Docket Number:	15-AFC-01
Project Title:	Puente Power Project
TN #:	220221
Document Title:	Closing Testimony of David Revell Phd on Proposed Puente Site
Description:	N/A
Filer:	PATRICIA LARKIN
Organization:	SHUTE, MIHALY & WEINBERGER LLP
Submitter Role:	Intervenor Representative
Submission Date:	7/14/2017 5:08:54 PM
Docketed Date:	7/17/2017

MEMORANDUM

Subject: Closing Testimony on Proposed Puente Site

Figure 1. Water level differences between dynamic wave set-up and maximum wave run-up.

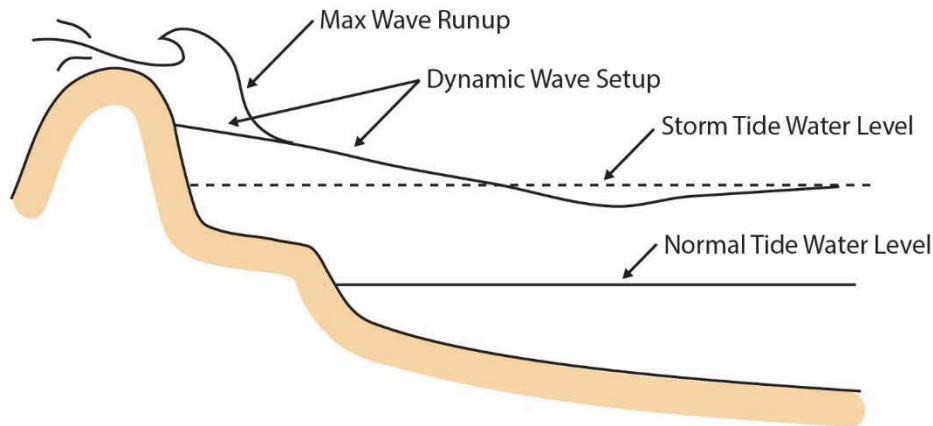
However, as discussed in detail below, my review of the COSMOS projected flood hazards reveals that the COSMOS model understates actual flood extents when it translates its reasonably-validated physical forcing parameters (waves and tides) into the actual mapping of hazard zones. Some of these discrepancies may be a result of the use of the dynamic wave set up water levels rather than total water level (tides + wave runup+dynamic wave run up) to predict flood hazards. Figure 1 is a conceptual definition figure showing the differences between water levels that result from using dynamic wave set up versus maximum wave run up or total water level. The use of a single topographic data set, which would reflect impacts based on only on one set of data at one particular time, may also understate hazards. However, the source of the apparent understatement of hazards remains unclear.

Figure 2A. COSMOS 3.0 Modeling at Oxnard Shores 100 year event, No sea level rise. Flooded area shown in light blue. Red arrows indicate approximate location (dot) and orientation of photo. Letters correspond to the ground photo figures for the site (Figures 2D, 2E, 2F).

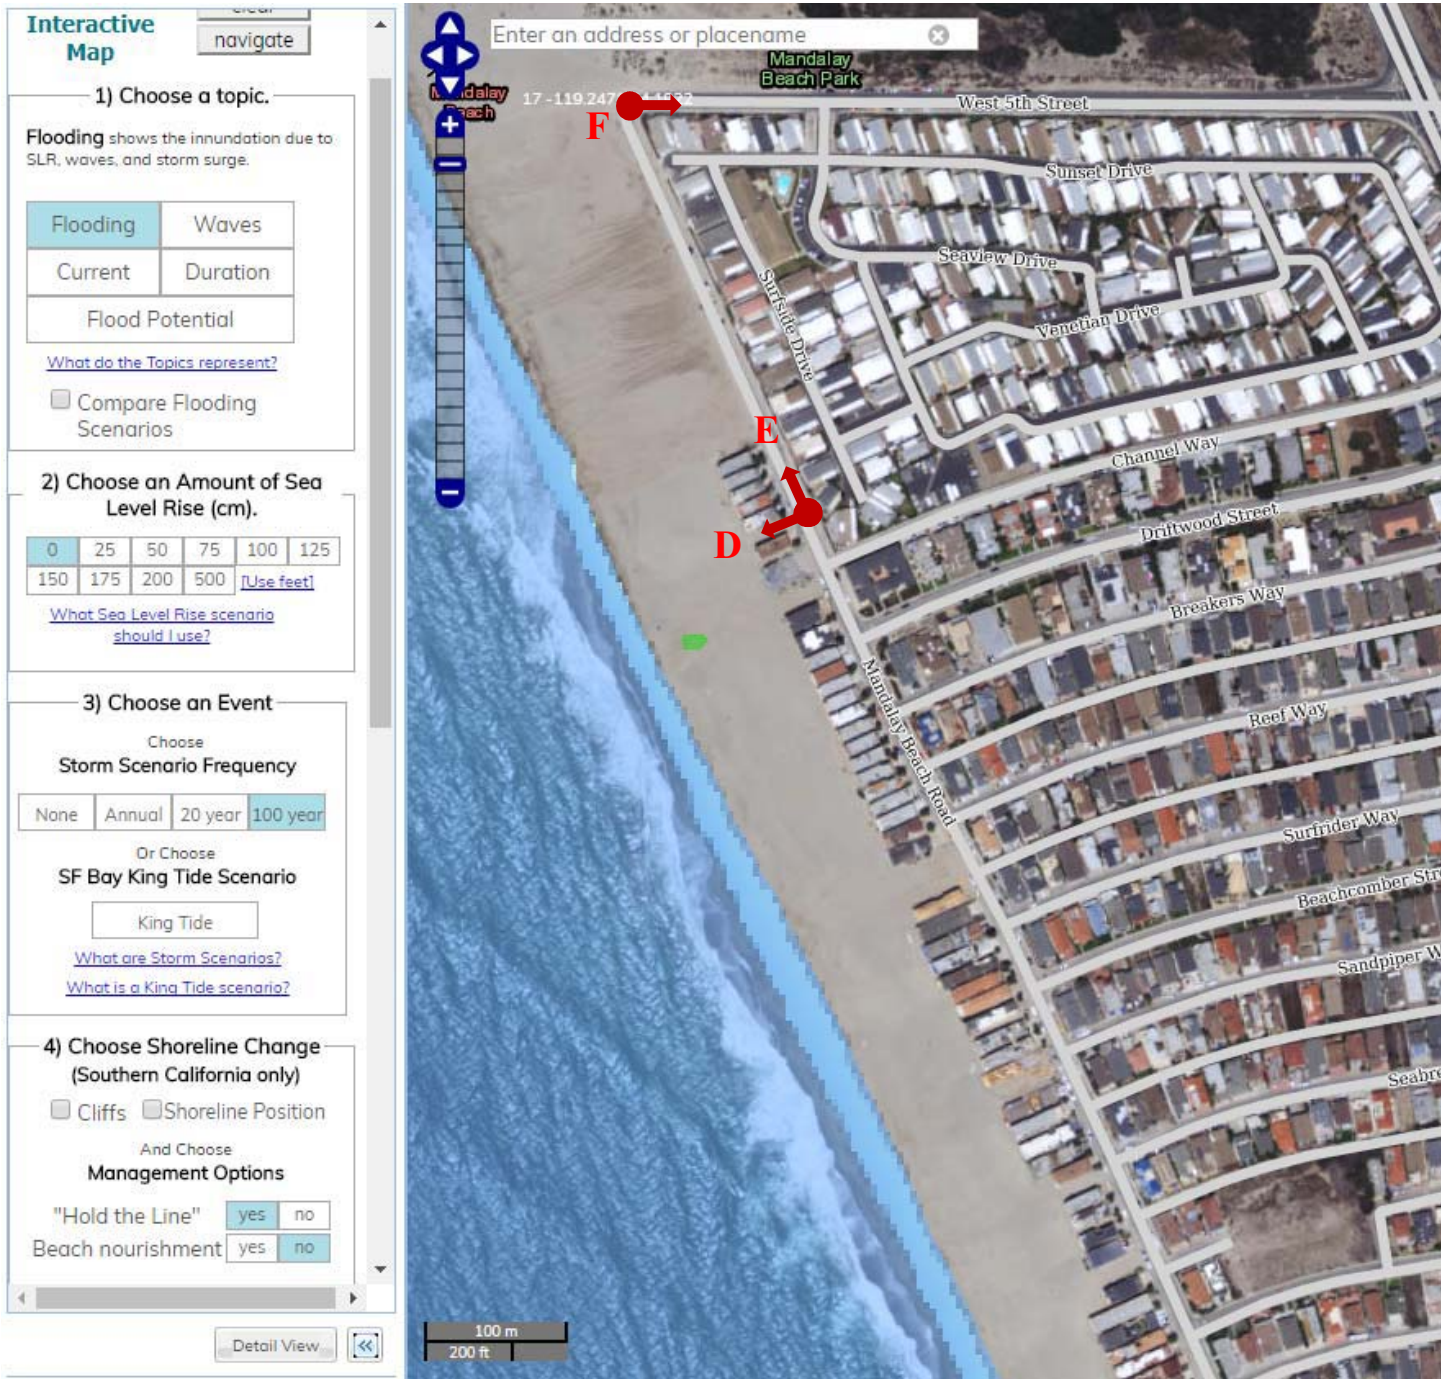
Summary

COSMOS 3.0	FEMA	Coastal Resilience
Cover the Beach?	NO	YES	YES
Match Observations?	NO	MOSTLY	YES

Figure 3A. COSMOS 3.0 Modeling at Pierpont 100 year event, No sea level rise. Flooded area shown in light blue. Red arrows indicate approximate location (dot) and orientation of photo. Letters correspond to the ground photo figures for the site.

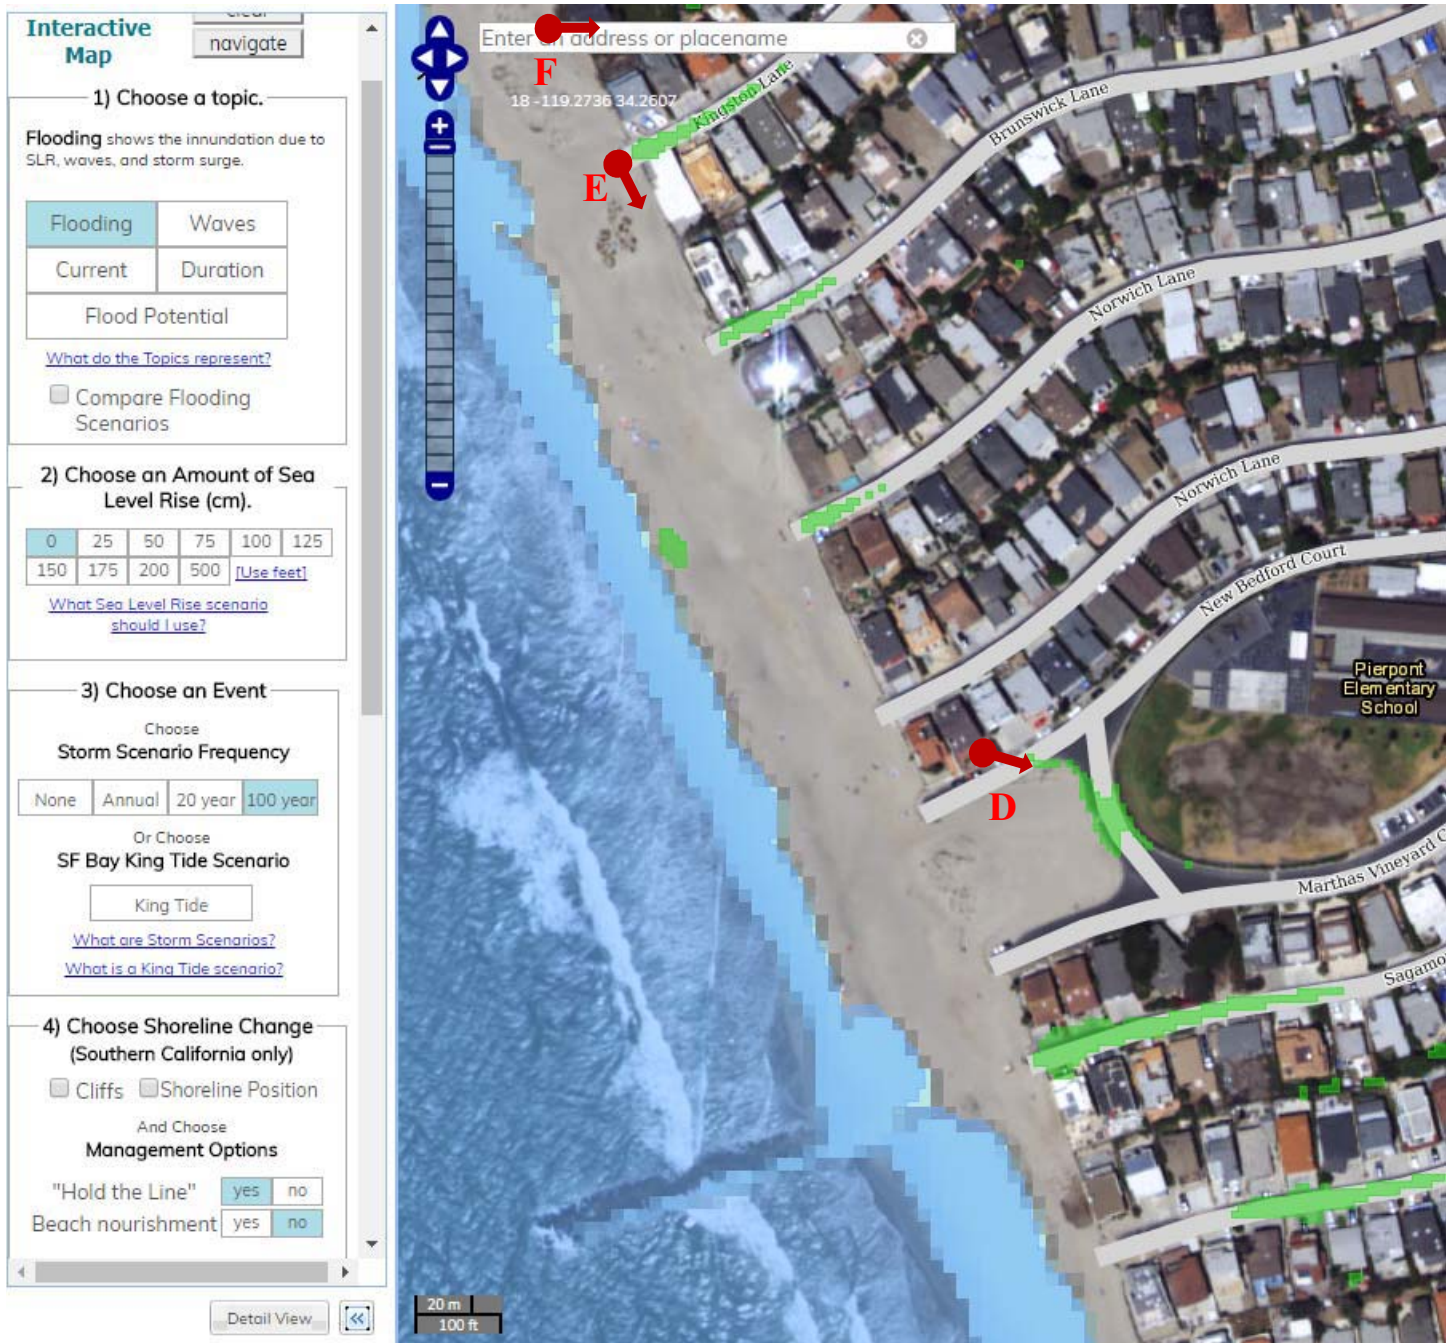
Summary

COSMOS 3.0	FEMA	Coastal Resilience
Cover the Beach?	NO	YES	YES
Match Observations?	NO	NO	YES

Figure 4A. COSMOS 3.0 Modeling at Goleta Beach 100 year event, No sea level rise. Flooded area shown as light blue. Red arrows indicate approximate location (dot) and orientation of photo. Letters correspond to the ground photo figures for the site.

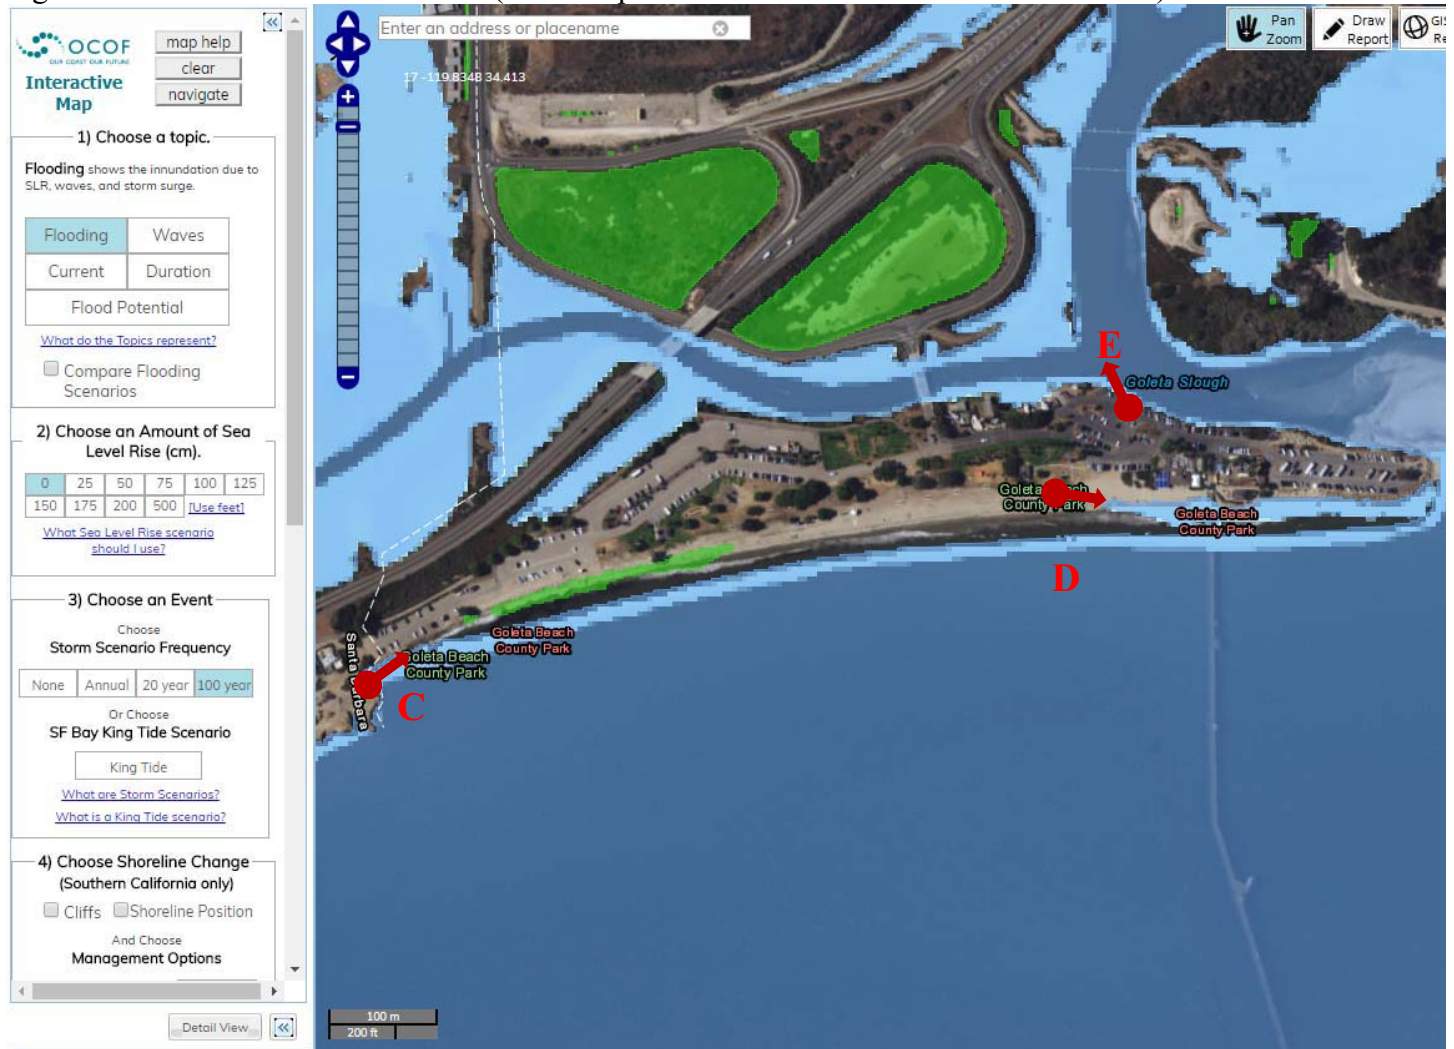
Summary

COSMOS 3.0	FEMA	Coastal Resilience
Cover the Beach?	NO	Not Available	YES
Match Observations?	NO	Not Available	YES

Figure 5. COSMOS 3.0 output of maximum flood potential for a 100 year wave event and No Sea level rise. The red circles simply allow for comparison of the same locations with Figure 6.

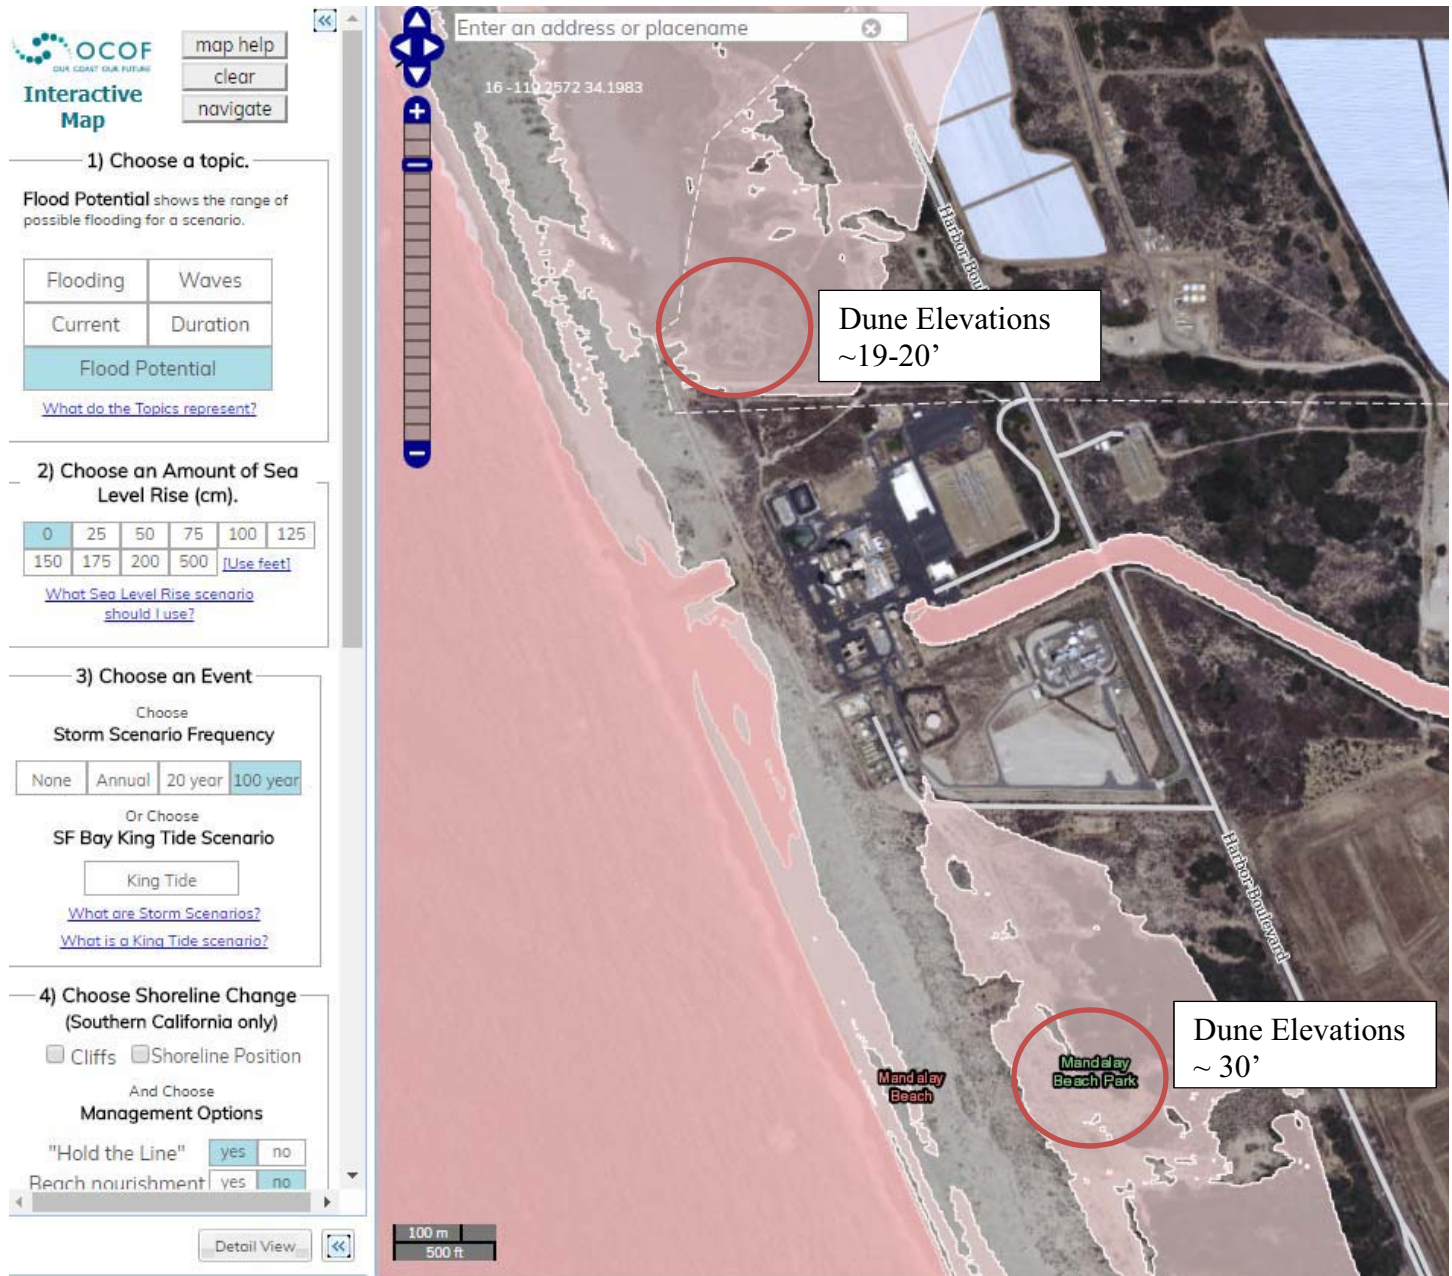
I also reviewed other aspects of the model performance in the vicinity of the project site. On this page and the following are figures taken from the Our Coast Our Future website (COSMOS webmapper) which shows the extent of flooding predicted by COSMOS at the project site. The first figure (Figure 5) shows the maximum flood potential (with uncertainty) for a 100 year wave event and No Sea Level rise. This figure shows two areas immediately adjacent to the site that are projected to be flooded (highlighted in the red circles.) The approximate crest elevations of these areas, based on LIDAR data, are depicted in the text boxes in the figure

and shown as 19-20 and 30 feet. The relatively flat Puente site has a ground elevation of ~14 to 14.5 feet (stated by the applicant and verified by multiple LIDAR data sets the LIDAR data.) Although the COSMOS models shows these higher areas would flood under existing conditions in a 100 year storm, the proposed project site (which is lower) does not. If this model is correct in the circled areas, then the proposed site should also be flooded given that there is no intervening berm or topography of sufficient elevation that would prevent water in these locations from flooding onto the project site.

Figure 6. COSMOS 3.0 output of maximum flood potential for a 100 year wave event and 2.0m (6.6 feet) Sea level rise. The red circles simply allow for comparison of the same locations with Figure 5. The green line is the approximate location of the flood depth comparison.

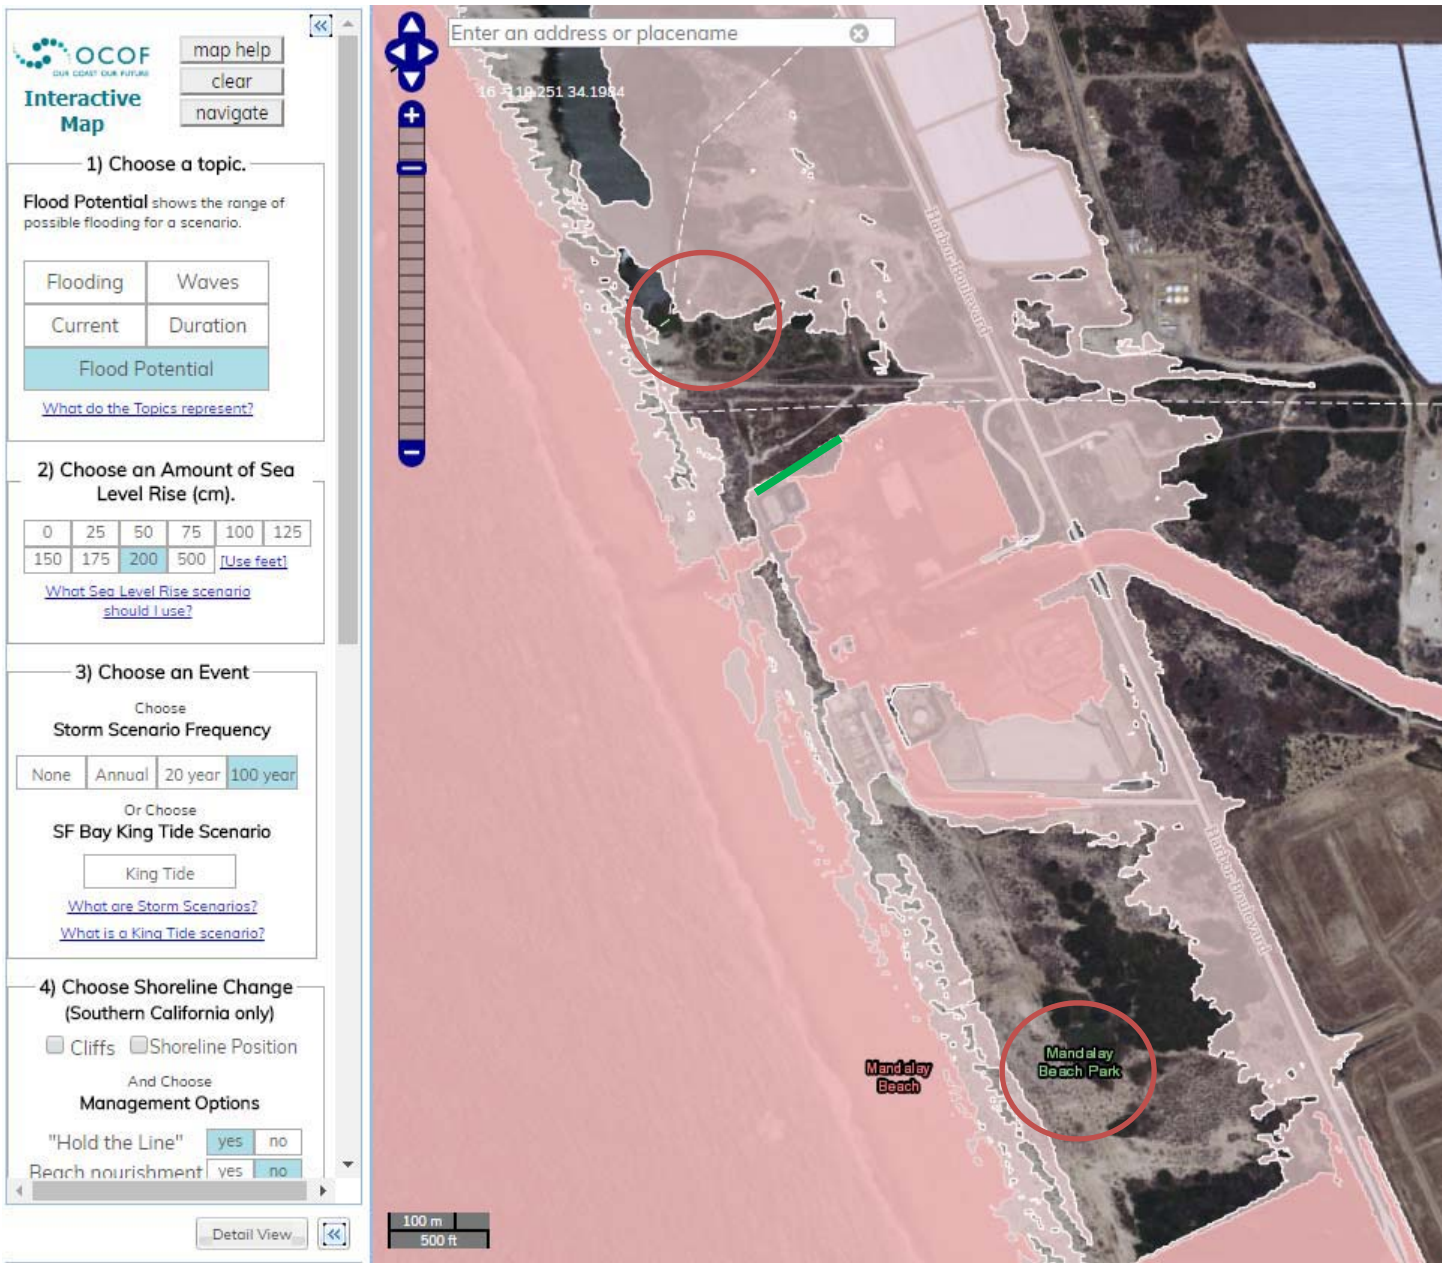
Figure 6 (which maps risks with 2 meters of sea level rise) demonstrates other discrepancies in the mapped flood hazards. First, the red-circled areas that were shown as fully flooded with no sea level rise in Figure 5 are now shown to have a substantial reduction in the maximum potential flood inundation area, even though water levels alone would have risen by 6.6 feet (2 meters).

Finally, regardless of the COSMOS flood potential and scenario used, the proposed site seems to avoid any flooding even though immediately adjacent, higher elevation areas are flooded. (Figure 7 in the Supplemental FSA). As a result, I reviewed the COSMOS projected flood depths for the site. At the green line depicted in Figure 6, the flood depth would range between 20-60 centimeters.² Based on my understanding of the COSMOS model, without any substantive topographic relief that would block 2 feet of water, this water should also flood the project site. If one wanted to be conservative and add the potential uncertainty regarding flood depths reported by USGS (0.68 m or 26.7 inches), it is extremely difficult to imagine that with up to a ~34 to 50 inch flood depth at the green line on a relatively flat site, that there would not be additional flooding into the proposed powerplant site beyond what has been mapped.

Both of these two flood depth issues seem to point to either some digital elevation model data issues or some discrepancies in the flow connections across the landscape.
